Re: 40 Main Street, Applications 18-D-07 and 18-UP-10; SB 35 Determination
Additional Specific Project Comments

Subject: 40 MAIN STREET, APPLICATIONS 18-D-07 AND 18-UP-10

This letter is in response to the Commercial Design Review and Use Permit application that was submitted on September 25, 2013 for a new office building at 40 Main Street. Based on our staff review, the application has been deemed **incomplete** for processing. While the City supports the general nature of downtown redevelopment and developing a new office building on the site, staff remains concerned that the project includes too many exceptions/variances from the zoning code. This letter is a summary of the issues that will need to be addressed.

Existing Parking Layout at 45°

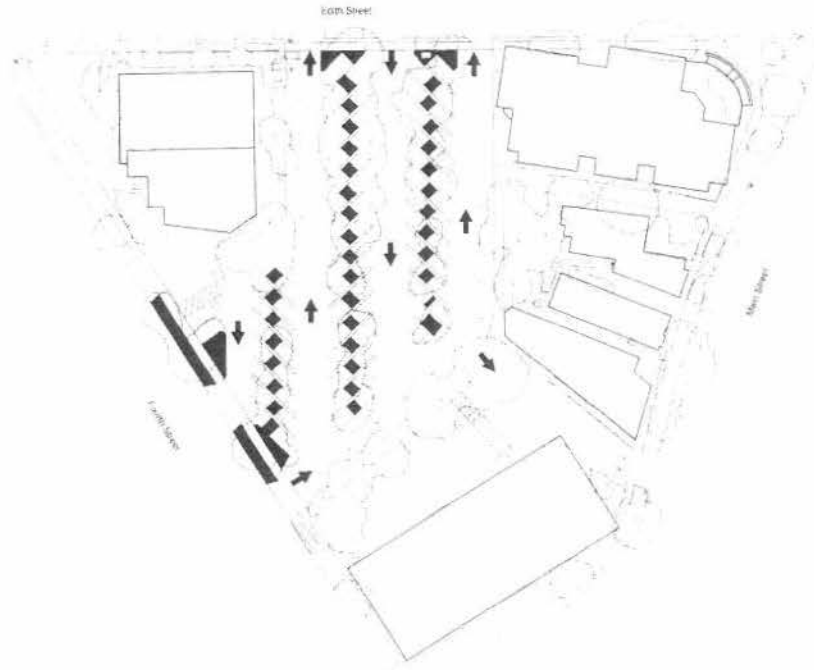
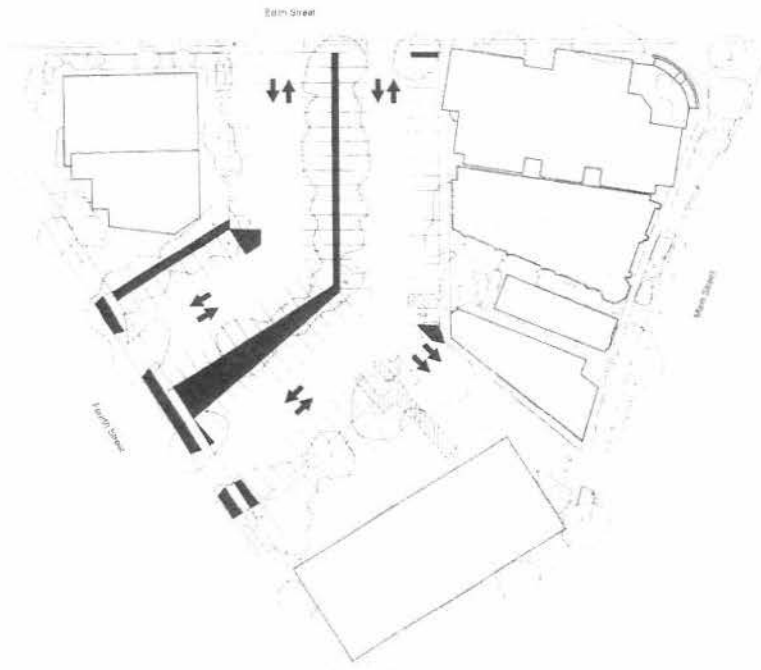
The application includes a conceptual plan to re-strip Public Parking Plaza 10 to add as many as 20 additional parking spaces. Chapter 14.74.170 in the Zoning Ordinance is not a policy that allows for private developers to reconfigure or redevelop public parking plazas in order to use that parking for their development. That is a public use of land that needs to be decided by Council policy, with the participation of the other parking district beneficiaries. This code section outlines that it is permissible for a developer to meet their parking requirements on adjacent properties that are within 300 feet of a proposed project, provided that the parking is not already being used by an existing development and that it is actually owned by the subject property owner or can be permanently allocated by deed to that project.

policy discussion, the proposed reconfiguration of Public Parking Plaza 10 will need to be revised to include the following information:

1. Show all existing property lines and easements.
2. Show all parking stalls consistent with the City's parking stall dimension requirements (nine feet wide by 18 feet deep).
3. Show all existing utilities and provide details for undergrounding all overhead utilities.
4. Show how the parking lot would treat storm water runoff per Best Management Practices and in compliance with the City's Municipal Regional Stormwater NPDES Permit (MRP).
5. The reconfiguration should only include parking spaces within Public Parking Plaza 10. On-street parking within a public street right-of-way is a separate topic.
6. A conceptual landscape plan which shows existing trees to remain, existing trees to be removed and new trees to be planted.
